# Accessibility Survey

## City of Downey Brookgreen Road - Elston Avenue to Elmont Avenue

Date of Inspection  
6/20/2017

**Disability Access Consultants**

#### Change in Level West of Elston Avenue @ 33.963921035420, -118.116962760687

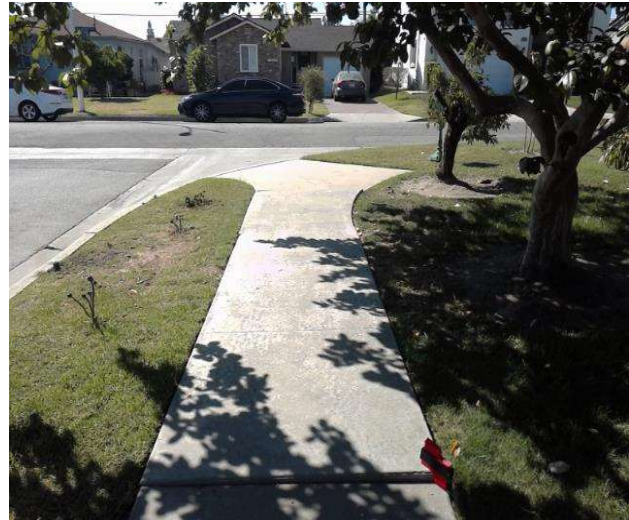
There is a change in elevation greater than recommended value.

**On-Site Finding** 1.50 inches

Ensure that the change in elevation is within the recommended value.

Recommendation Up to 0.25 inches

**Change in Level West of Elston Avenue @ 33.962561796359, -118.115262240171**

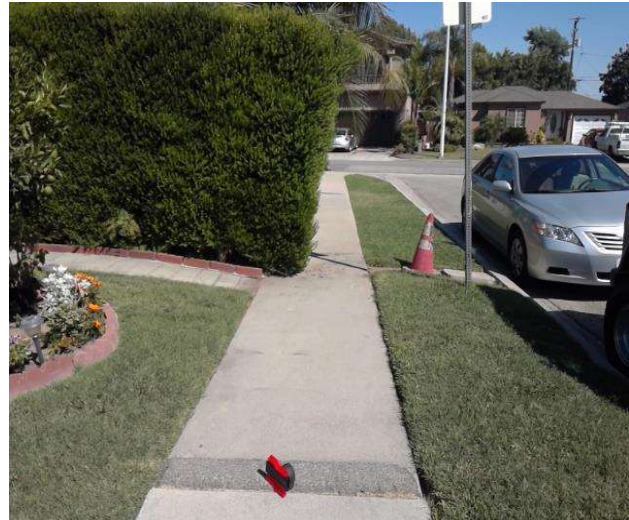
There is a change in elevation greater than recommended value.

**On-Site Finding** 0.50 inches

Ensure that the change in elevation is within the recommended value.

Recommendation Up to 0.25 inches

#### Sidewalk West of Elston Avenue @ 33.963921035420, -118.116962760687

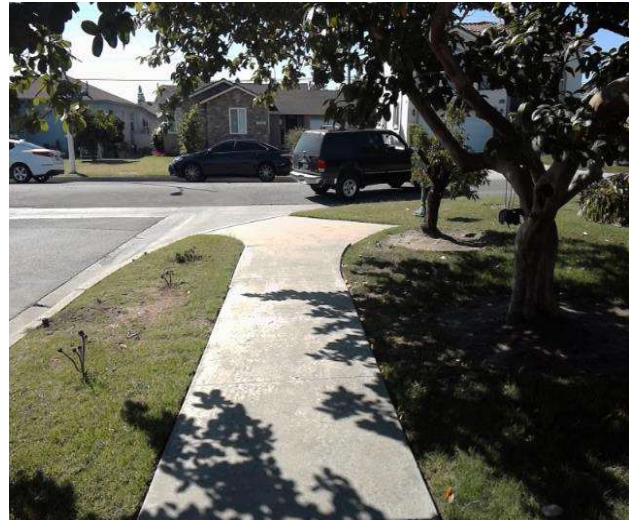
Sidewalk cross slope is not compliant.

**On-Site Finding** 3.60 percent for 18.00 feet

Repave the sidewalk surface with the recommended cross slope.

Recommendation Up to 2.08 percent

**Tree West of Elston Avenue @ 33.963921035420, -118.116962760687**

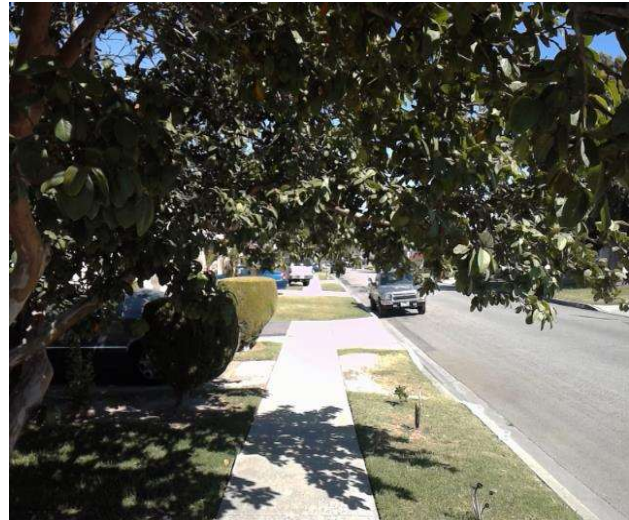
Overhead obstruction height is not compliant.

**On-Site Finding** 67.00 inches

Provide a compliant vertical clearance height.

Recommendation At least 80.00 inches
